Subject: AP1000 Response to Request for Additional Information (SRP3.9.2)

# AP1000 TECHNICAL REPORT REVIEW

RAI Response Number: RAI-SRP3.9.2-EMB1-01  
Revision: 1

RAI Response Number: RAI-SRP3.9.2-EMB1-11  
Revision: 1

Figure 1

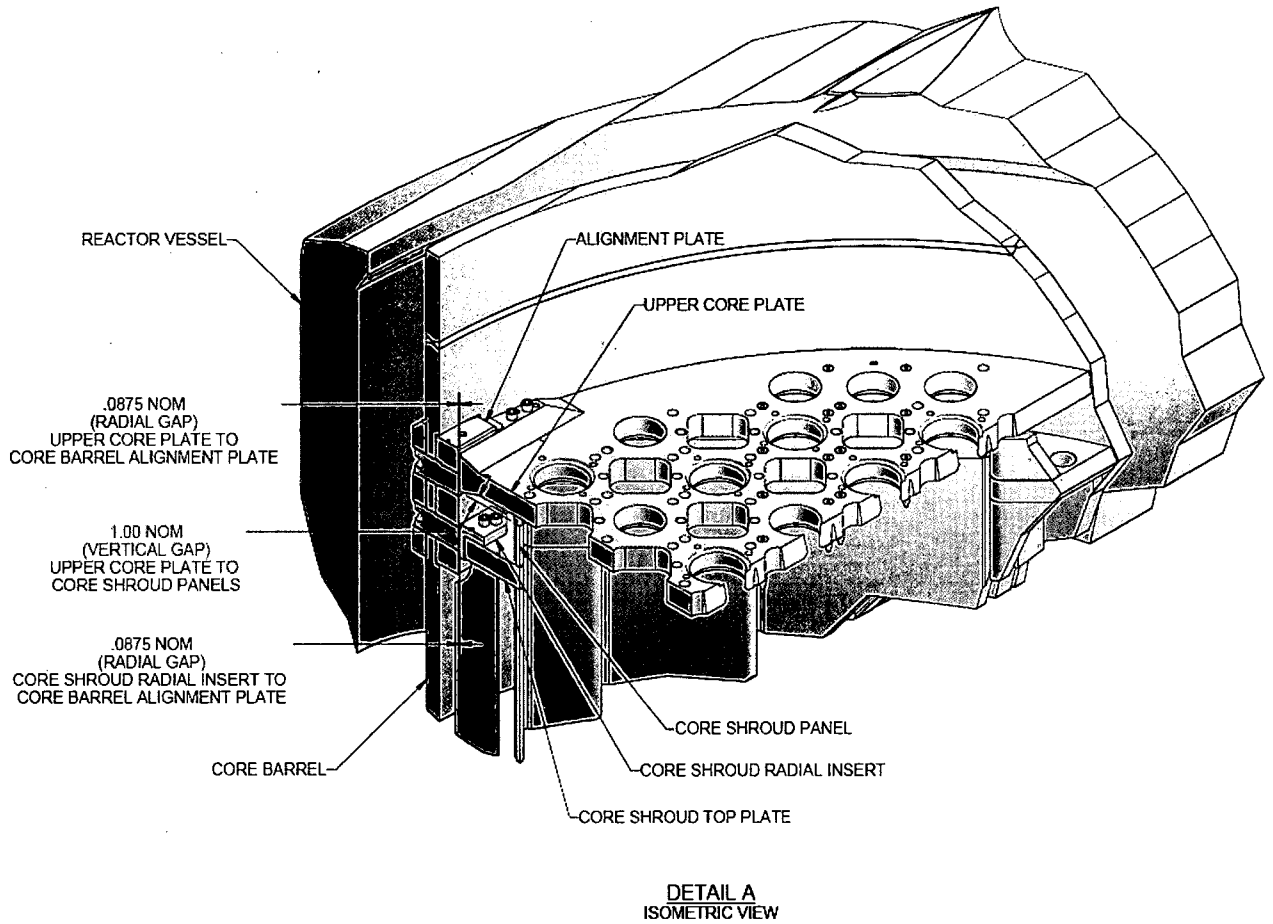
Describe the design and modeling of the core barrel/upper core plate as they relate to flow-induced vibration (FIV) structural dynamic analysis. What is the uncertainty that the model of the interface employed in the modal analysis is representative of the physical support?

The upper core plate is modeled as a part of the upper internals in the system model. The gaps between the upper core plate (and core shroud) slots and the alignment plates mounted on the core barrel are also modeled (see Figures 1 and 2).

To ensure that the entire range of possible gaps between the upper core plate and the core barrel alignment plates is evaluated, time-history analyses were performed with various sets of gaps (upper core plate, top core shroud plate, and core barrel lower supports). Table 6-9 in WCAP-15949-P, Rev 2 (Reference 1), shows the gaps modeled and the resulting loads. The resulting highest load was used in the structural analysis.
